DESIGN IMPROVEMENTS

KT59-62001 Kenworth Motor Mount Kit (rear)

Application: Kenworth T-600 Motor Mount

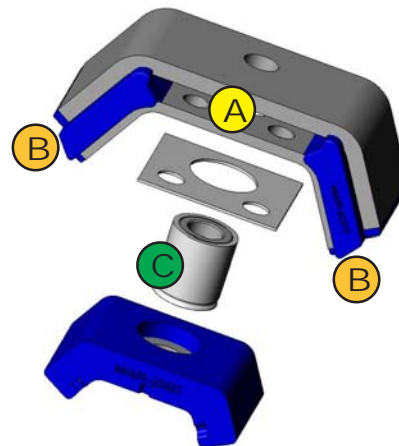
- A** Original ATRO parts had polyurethane at this location. Removal of the polyurethane decreases stiffness (rigidity) of mount and allows for better performance and less vibration.
- B** Added polyurethane protrusions to one side of top mounts, making part similar to O.E. design. This change helps to control lateral movement of engine.
- C** Original ATRO part had two-piece welded spacer sleeve. New design has one-piece spacer sleeve. This change eliminates the need to over raise the engine during installation of the top (larger) mount, resulting in an easier install. Lower (smaller) mount has snap groove to locate spacer sleeve for easier installation. The one-piece metal design vs. the two-piece design offers better torque application of fasteners.
